Defining the training patterns

NVIDIA

Comments 414 and 415

D1.2 PRBS13Q and proposed improvement

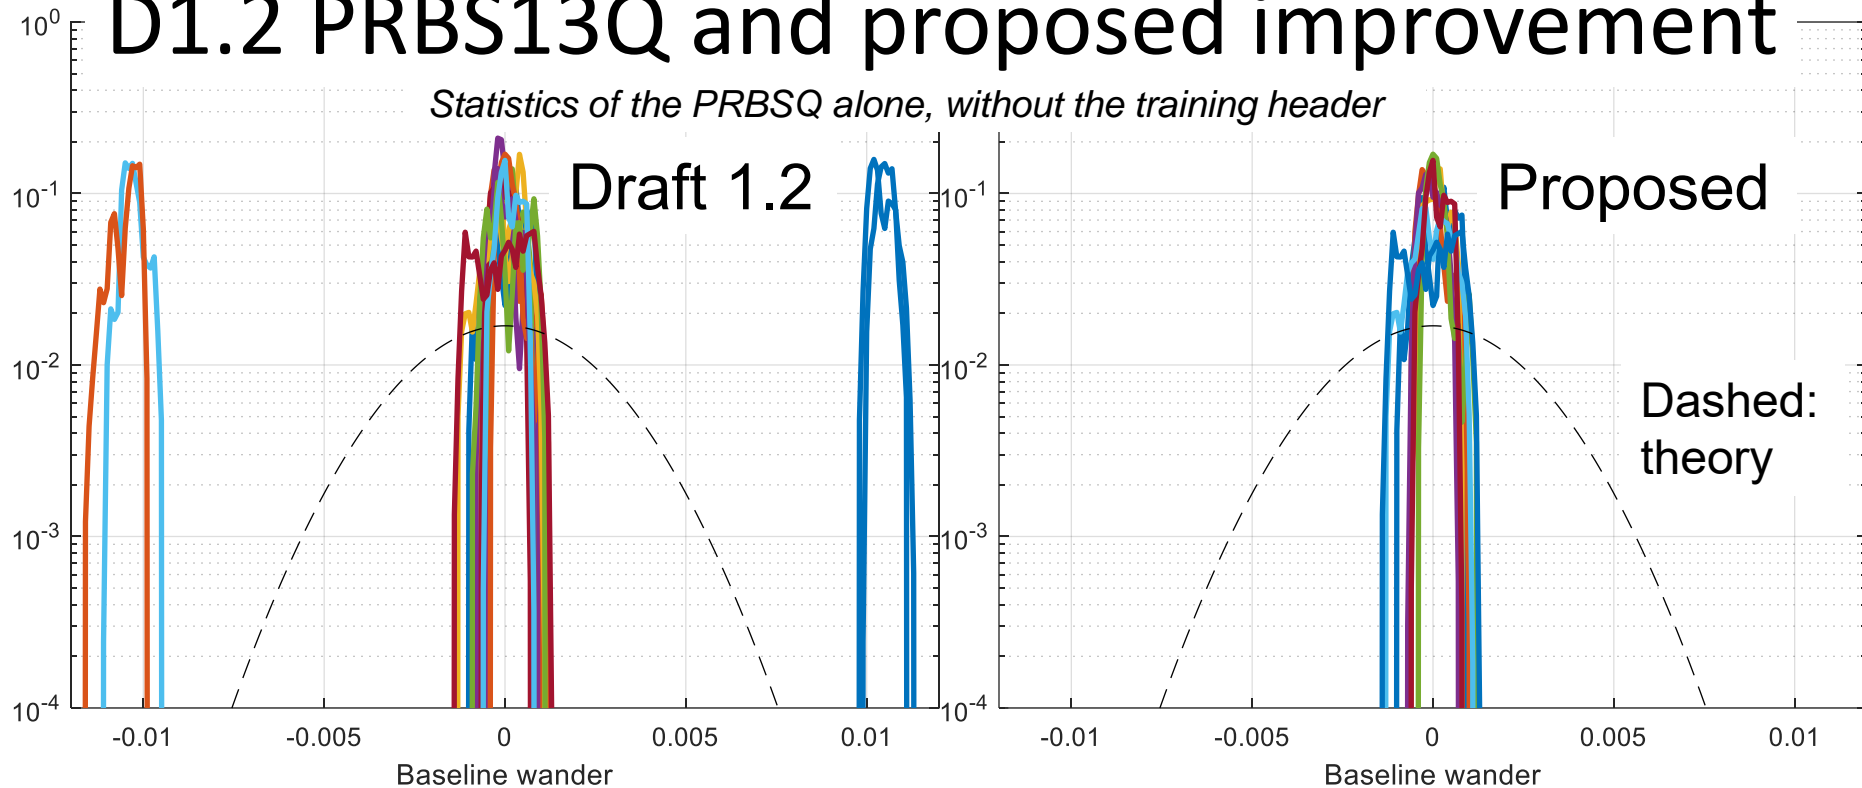
- Baseline wander statistics of the possible PRBS13Q, 4 polynomials, both precoded and not, any seed
- Four unbalanced patterns should be avoided
 - The standard should warn against creating these
- The two on the left are precoded, i is 1 or 5, with the default seed
 - The two on the right are precoded, "Default identifier" (polynomial ID) 3, and a non-default seed
- Some patterns are 8191 UI long, some precoded patterns are 16382 UI long

- Baseline wander statistics of the proposed set of PRBS13Q, 4 polynomials (8 i), both precoded and not, revised default seeds
- The unbalanced patterns are avoided
 - for the proposed default seeds
- The 4 non-precoded patterns are 8191 UI long, the 4 precoded patterns are all 16382 UI long
 - Nice minor benefit

Revised default seeds (for both synchronous and free-running)

<i>i</i>	Default identifier (ID of polynomial)	Default seed_ <i>i</i>		Comments
		D1.2	Proposed	
0	0	0000010101011	0000010101011	
1	1	0011101000001	0111010000011	Rotated 1 bit
2	2	1001000101100	1001000101100	
3	3	0100010000010	0100010000010	
4	0	1111110100110	1111110100110	
5	1	1100011101110	1000111011100	Rotated 1 bit
6	2	0000001101000	0000001101000	
7	3	0011000100111	0011000100111

Checking the correlations

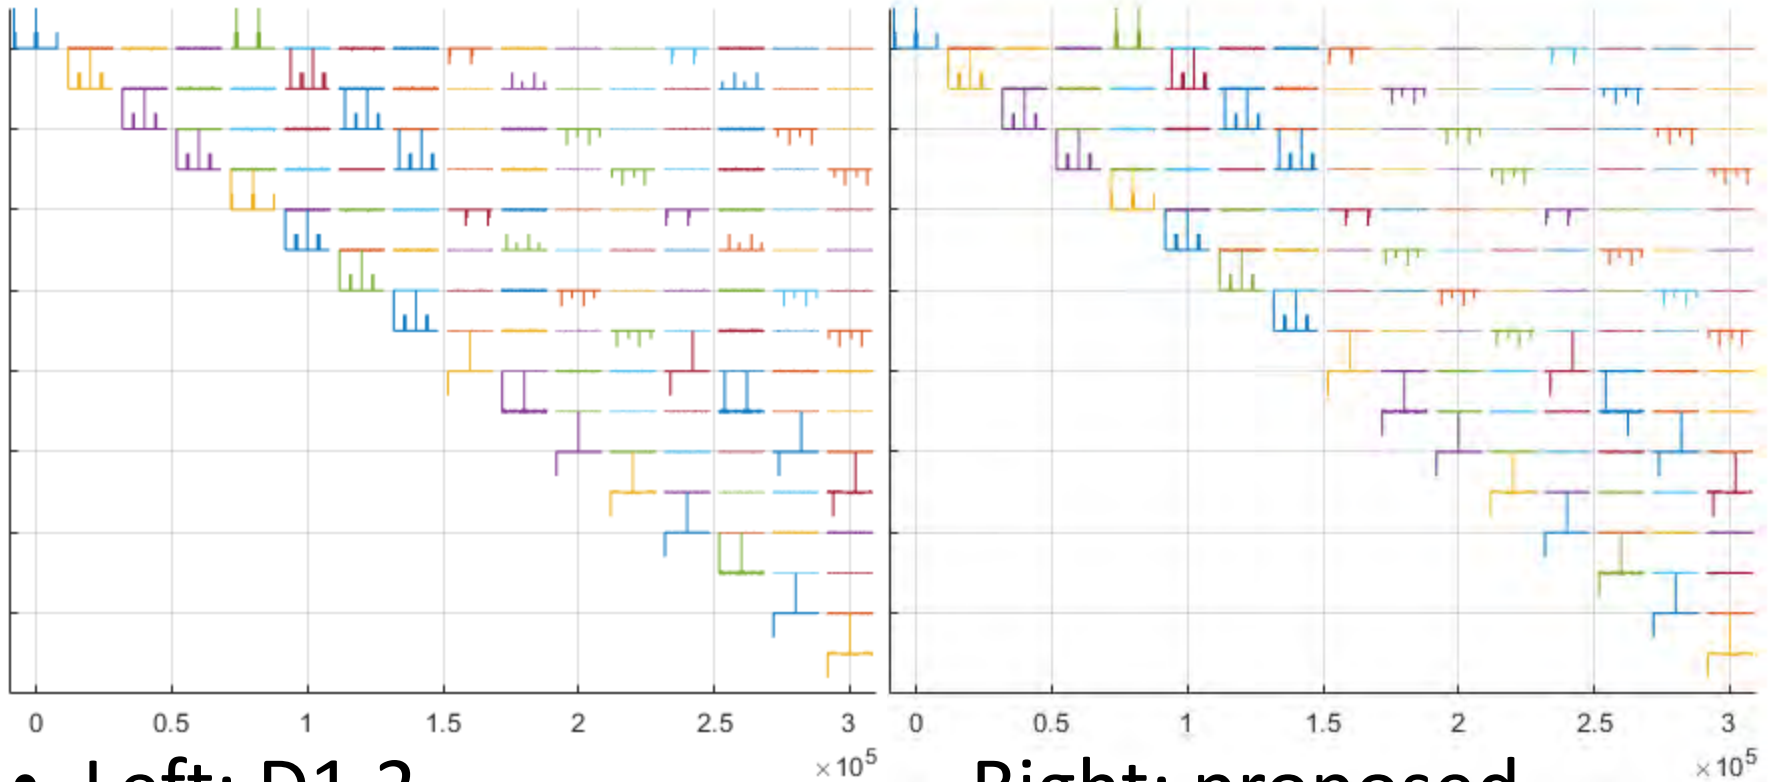
- Left: D1.2
- Right: proposed
- The sign of some correlation peaks is changed
- Otherwise, no significant difference. See table on next slide, and backup slides

Candidate PRBS31Q

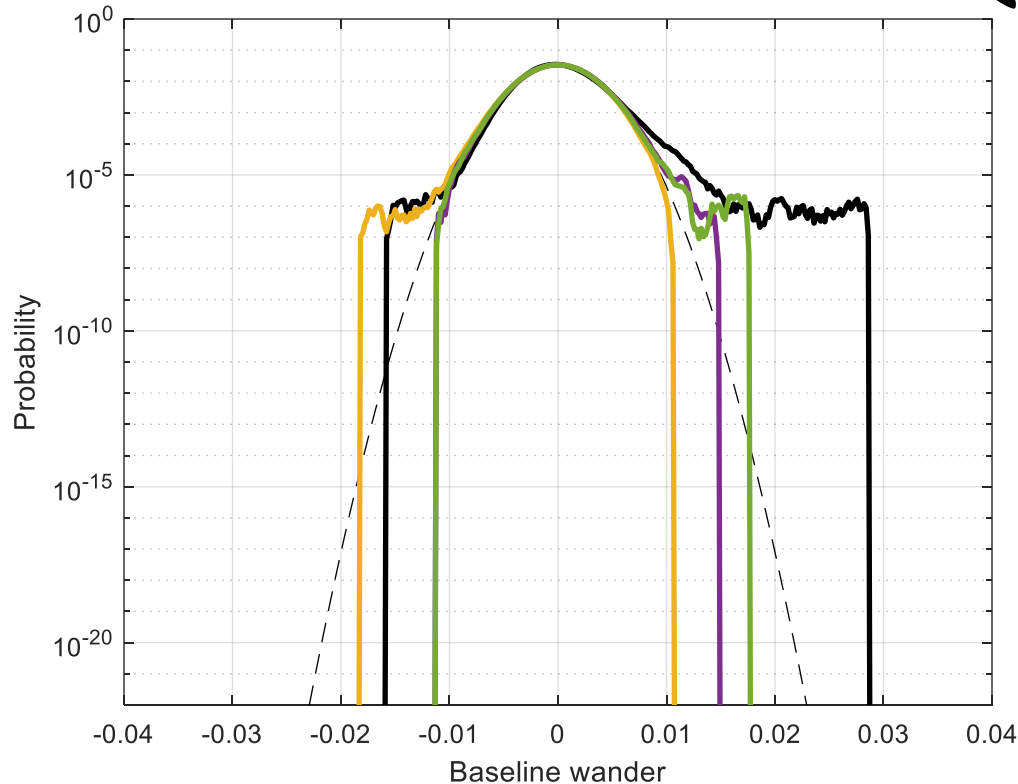
- Black: Not precoded. More challenging than real traffic, best for conservative testing
- Yellow, green and purple: precoded
- Purple is the most representative for baseline wander – best for training
- Also its transition density statistics are somewhat better than un-precoded PRBS31Q
- This is the recommended choice. As it happens, it is also the default, if the PRBS31 is initialised as in 120.5.11.2.2 (seed is all 1s). So define it like this
 - As already stated in the draft, different initializations should be used for different lanes

- An acceptable set of PRBS13Q can be defined by shifting two seeds by one bit
- A unique precoded PRBS31Q can be defined, with better statistical properties for training than regular PRBS31Q

D1.2 PRBS13Q and proposed improvement

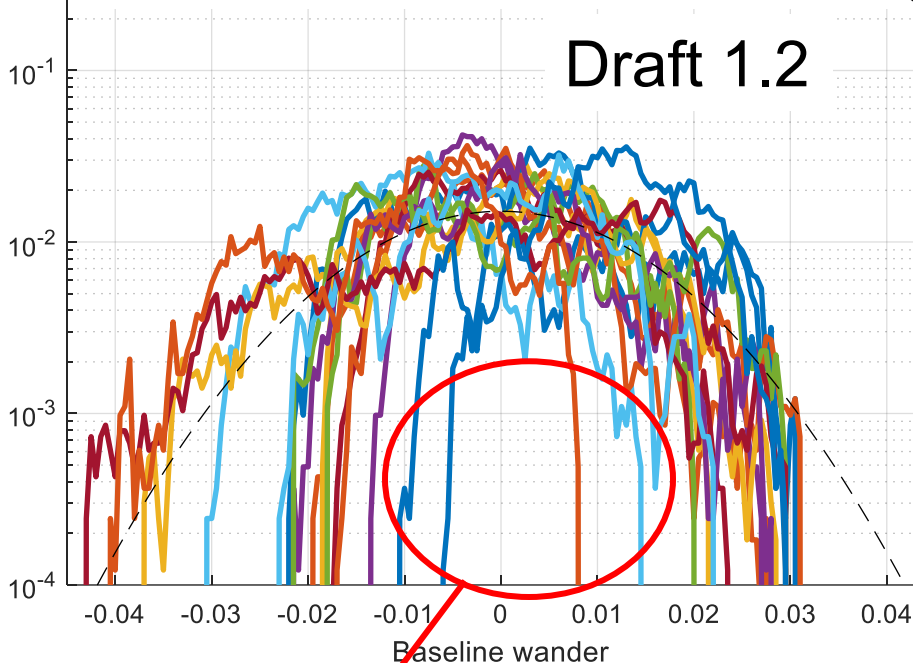
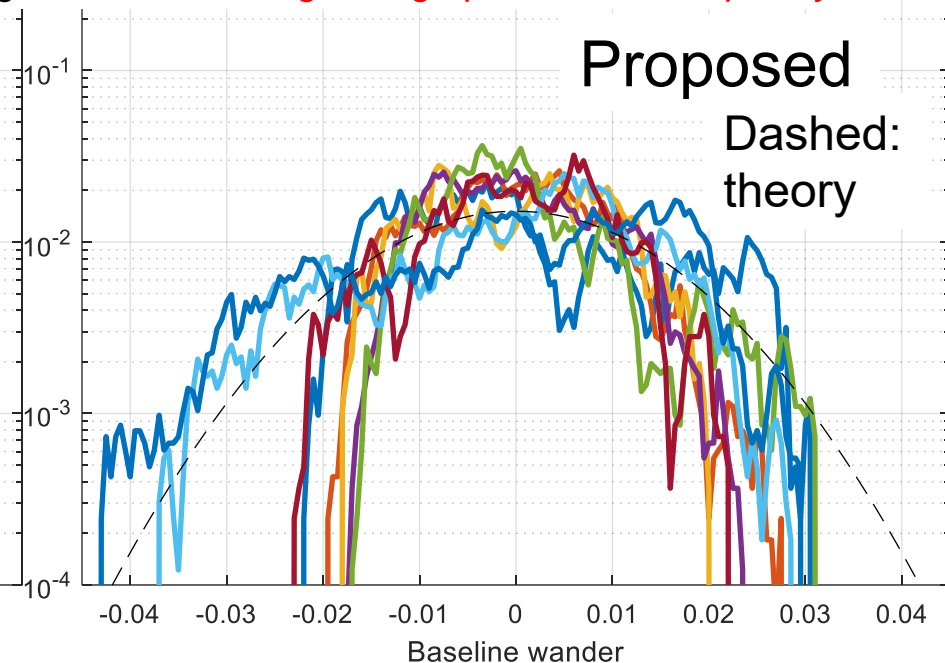
- Baseline wander statistics of the possible PRBS13Q, 4 polynomials, both precoded and not, any seed
- Four unbalanced patterns should be avoided
 - The standard should warn against creating these
- Some patterns are 8191 UI long, some precoded patterns are 16382 UI long

- Baseline wander statistics of the proposed set of PRBS13Q, 4 polynomials (8 i), both precoded and not, revised default seeds
- The unbalanced patterns are avoided
 - for the proposed default seeds
- The 4 non-precoded patterns are 8191 UI long, the 4 precoded patterns are all 16382 UI long
 - Nice minor benefit
